Addendum No.1 Page 1 of 4

#### KERN TULARE WATER DISTRICT

Project: Kern-Tulare Water District Guzman Reservoir

#### **NOTICE TO ALL BIDDERS**

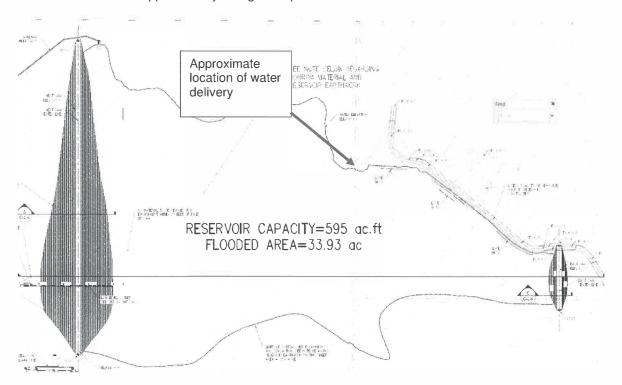
WATER AVAILABILITY: Non-potable water is available from a 12 inch irrigation pipeline that is terminated on the site in location shown below. Water will be provided to the contractor at no cost. The pipeline is currently capped off, and it will be the responsibility of the contractor to install the water delivery infrastructure of their choice. Water is capable of being delivered to the contractor at a rate of approximately 900 gallons per minute.

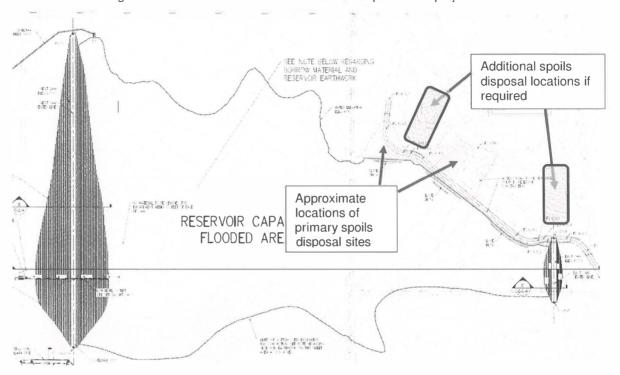
2. SPOILS DISPOSAL. Grubbed and unsuitable soils materials may be disposed of on the neighboring site north east of the project site. The approximate location is shown in the following illustration. Grading of the access road shown in this area is not part of this project.

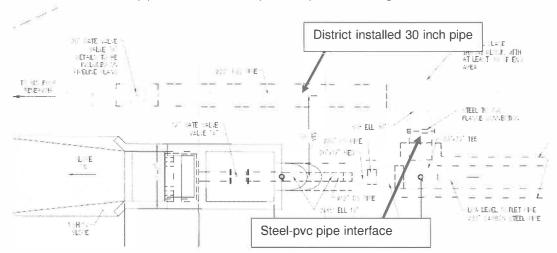
After the contractor has completed grubbing operations for the site, a field survey will be performed by the owner to establish the baseline pay surface. Excavation quantities will be calculated by the surveyor based upon the amount of material that has been removed from the overex or borrow area. After overexcavation is complete a survey will be performed to establish the base surface for fill within the dam footprint. The embankment pay quantity will be based on the amount of fill placed above this base surface at the three embankment locations.
